Access Compliance Report Public Rights-of-Way (Curb Ramps)

Main Street: WASHINGTON_AVE		Cross Street: NEWLAND_ST		Location:	SE
ADA ID: RPRK211001115139	Ramp Type:Type 1 - Perpendicular Diagonal Initial Pass/Fail: Pass		Overall Compliance: No	Severity Score:	12

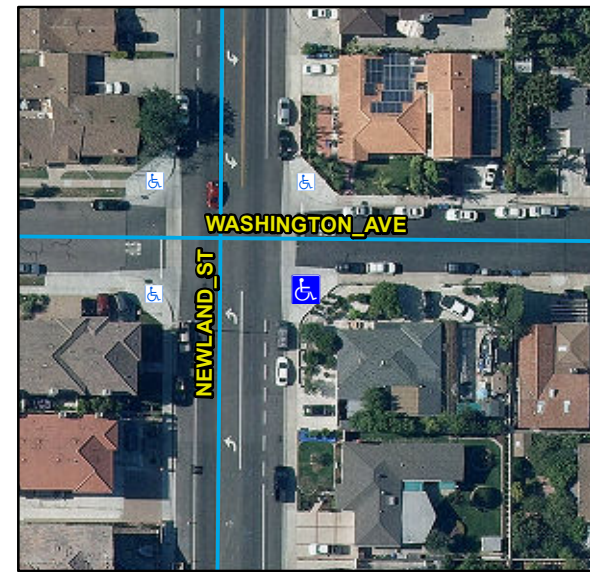
R304.2.2, R304.2.1, R304.2.2-Perp, R304.3.2-Para, R304.5.3, R304.2.3, STD 1115

Remove & Replace Curb Ramp With Two New Directional Ramps or Equivalent.
